Owner Notification Program
ONP 2007-02

November 20, 2007

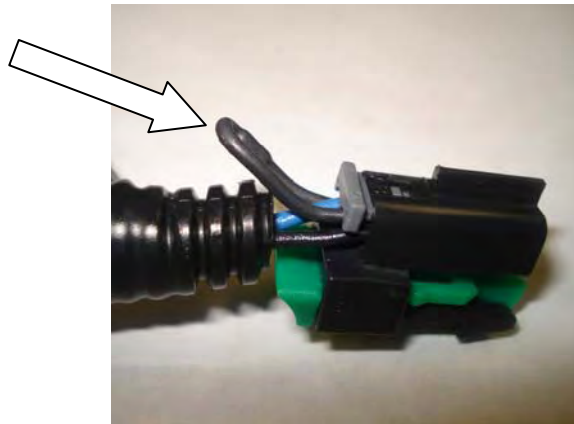
If **all** of the above criteria are met, inspect the ILIS605-H3 Activation Harness to determine if further action is required. This harness is attached to the shift lock solenoid under the steering column. Inspect at the solenoid connector for the presence of a jumper going from the blue wire to the black wire. This is the diode. It may be necessary to pull back the plastic conduit to get a better view. See photo.

If there is no diode present, the vehicle is not affected by this notification. If there is a diode present, proceed with this Owner Notification Program.

- Set parking brake, turn on ignition, and allow the Interlock display to prove out. Verify that the gear selector is locked and that you cannot shift out of Park. Release the parking brake. You should now be able to shift out of Park.
- If vehicle passes above test, contact InterMotive for a J01A1 Harness Kit. The kit comes with installation instructions and can be installed in about 5 minutes.
- If the vehicle did not lock the gear selector, contact InterMotive for a new Gateway Module and a J01A1 Harness Kit. **The J01A1 Harness must be properly installed prior to replacement of the new Gateway Module or the module may be damaged.**
